Application for Amendment

Application under the *Agricultural Operation Practices Act* to amend a permit for a confined feeding operation, manure collection area and/or manure storage facility(ies). ("Permit" means an NRCB-issued or grandfathered approval, registration, or authorization, including a grandfathered municipal development permit.)

Which permit do you wish to amend? (List permit number and issuing agency.)	LA21053 NRCB
Legal Land Description(s)	S ½ 8-21-24 W4M N ½ 5-21-24 W4M

Applying to change the dimensions of the catch basin to 177 meters long x 67meters wide x 3.29 meters deep.

Catch Basin Dimension Calculator

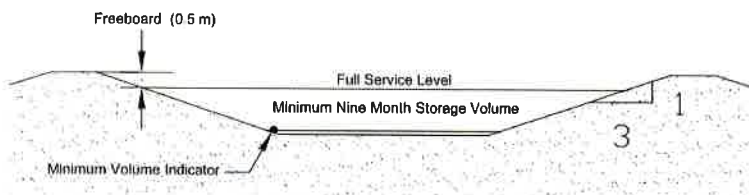
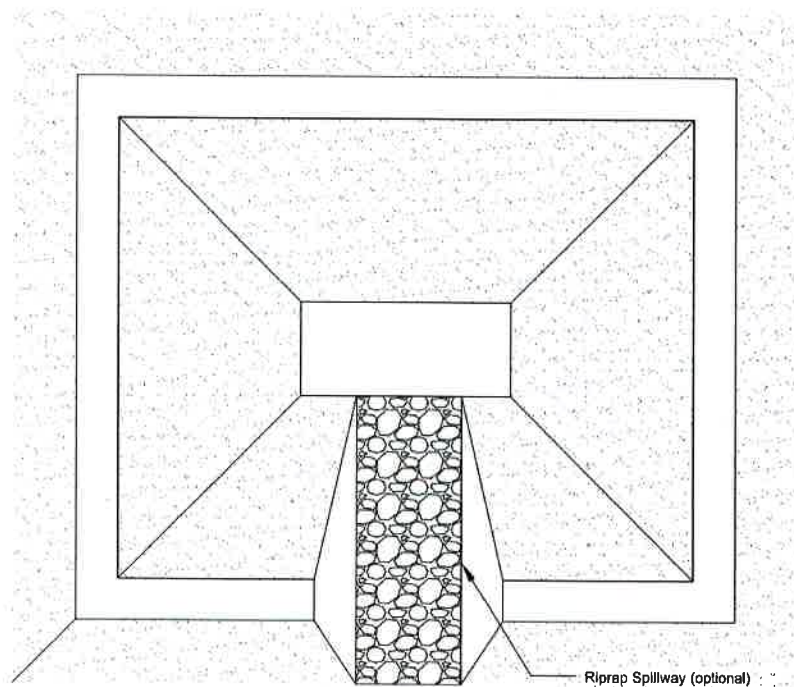
The purpose for the change is to increase depth of the catch basin to help facilitate better drainage from pens into the catch basin.

Length (m):	177	174.0
Width (m):	67	64.0
Depth (m):	3.29	2.79

25772 m³
 910130 ft³
 5669047 Imp. Gal

The catch basin dimensions meet the design requirements in AOPA
